# SWITCH GREASE TO STOP O-RING SWELLING

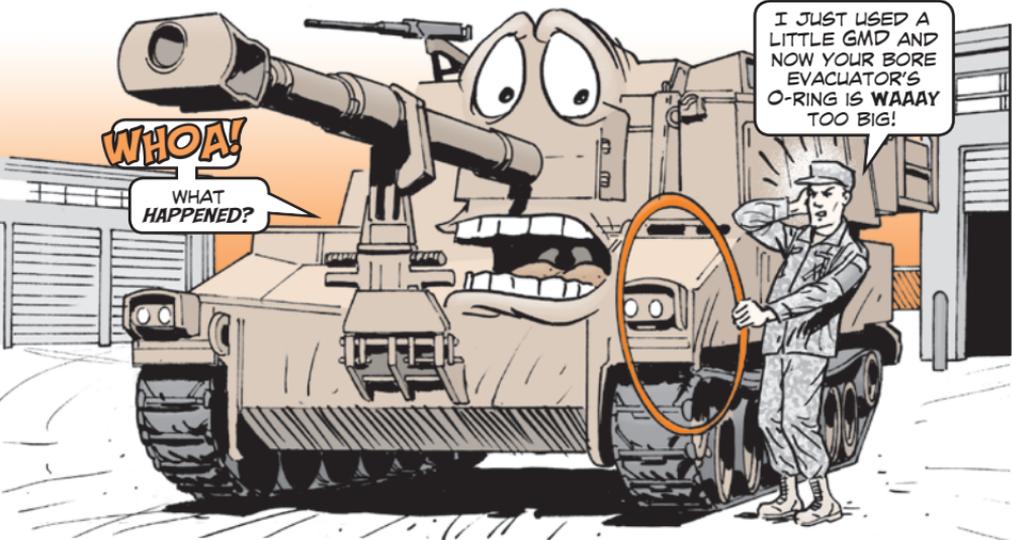
CREWMEN, O-RINGS FROM THE BORE EVACUATOR ON THE PALADIN'S GUN TUBE SOMETIMES **SWELL** SO MUCH AFTER BEING REMOVED FOR MAINTENANCE THAT THEY CAN'T BE REINSTALLED.

TESTING HAS SHOWN THE SWELLING IS CAUSED BY GMD, SO STOP USING THAT GREASE **NOW**.

INSTEAD, USE GENERAL PURPOSE GREASE (GGP) OR GAA WHEN LUBING O-RINGS.

Get a 14-oz tube of GAA with NSN 9150-01-197-7693. A 1<sup>3</sup>/<sub>4</sub>-lb can comes with NSN 9150-01-197-7690 and NSN 9150-01-197-7689 gets you a 6<sup>1</sup>/<sub>2</sub>-lb can.

Get a 1<sup>3</sup>/<sub>4</sub>-lb can of GGP with NSN 9150-00-985-7316 and a 35-lb can with NSN 9150-00-823-8047.
